This document analyzes the questions posed by the NRC in the inspection report that resulted from NRC Triennial Fire Protection Inspection 2003-007.

Each of these items is addressed in detail below. This analysis was prepared by Mike Yungbluth, Electrical Design Engineer, and was reviewed by Rich McCann, Electrical Consulting Systems Engineer. Input was also provided by other site experts.

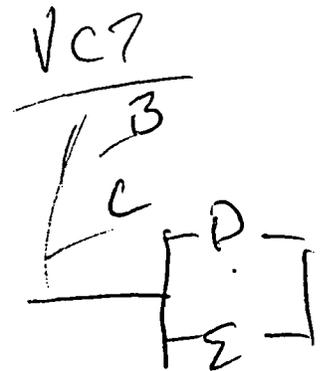
NRC Concern: A fire in area C-9 could cause spurious closing of a volume control tank outlet valve, causing a loss of charging, affecting reactor coolant inventory control and reactor coolant pump seal cooling.

Cable failure for cable 1BGG12AC could cause BGLCV0112B to spuriously close. The control room operator response to this off normal spurious operation would be to open B train valve BNLCV0112E which would provide the suction source (RWST) of water to the B Centrifugal Charging Pump. Cables for BNLCV0112E are not in fire area C-9. B train valve BGLCV0112C provides VCT outlet isolation if required.

*manual action allowed?*
